Item Name: Crosstube Assembly, Mid Fwd

DRAWING NO. REV. A
D206-667-147 SHEET 1 OF 4

DRAWING NO. D206-667-147	TITLE CROSSTUBE ASS'Y (206L MID FWD)	REV. A	DART AEROSPACE LTD ENGINEERING ORDER		D.E.O. NO. D206-667-147-A-1	SHEET NO. SHEET 1 OF 1	SCALE NTS
DRAWN <i>Q</i>	CHECKED <i>ASS</i>	MFG. APPR. <i>MD</i>	APPROVED <i>MD</i>		DE APPR. <i>MD</i>		
DATE 11.07.15	DATE 11.07.20	DATE 11.07.21	DATE 11/07/21		DATE 11.07.21

DRAWING NO. D206-667-147	TITLE CROSSTUBE ASS'Y (206L MID FWD)	REV. A	DART AEROSPACE LTD ENGINEERING ORDER	D.E.O. NO. D206-667-147-A-2	SHEET NO. SHEET 1 OF 1	SCALE NTS
DRAWN AJS	CHECKED	MFG. APPR.	APPROVED	DE APPR.		
DATE 12.08.02	DATE 12.08.02	DATE 12.08.02	DATE 12.08.02	DATE 12.08.02	DATE 12.08.02

DETAIL P
BONDING STRAP INSTALLATION 2 PL

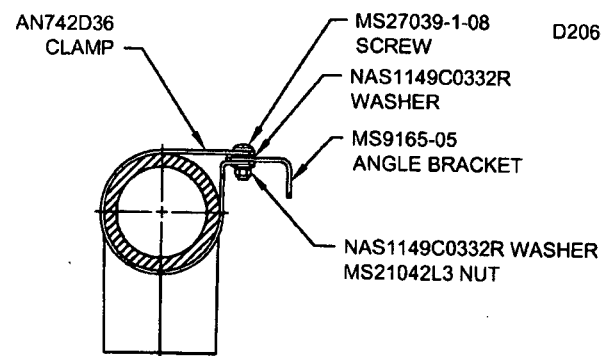
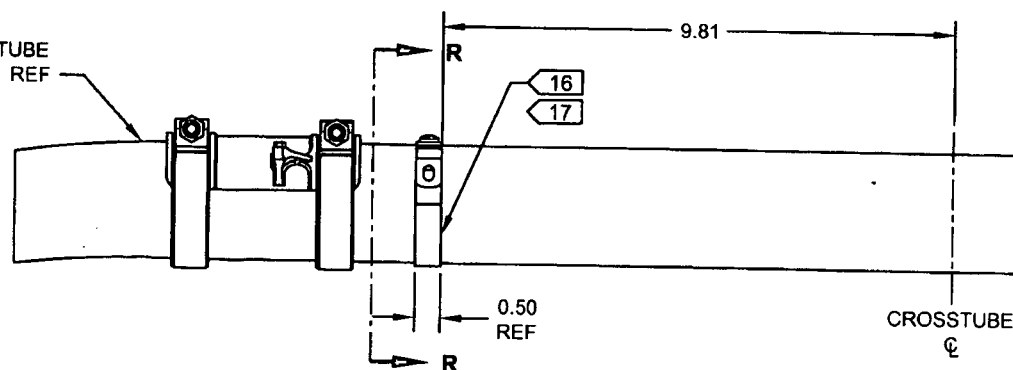
ADD ELECTRICAL GROUNDING STRAP

- 16) MASK AREA UNDER CLAMP PRIOR TO PAINTING
- 17) SEAL EDGES WHERE AN742D36 CLAMP MEETS WITH THE CROSSTUBE USING SIKAFLEX-241/-291 OR MIL-S-8802 CLASS B2 OR PROSEAL 890 SEALANT
- 18) PERFORM RESISTANCE CHECK TO ENSURE MAX RESISTANCE IS 10 MILLIOHMS
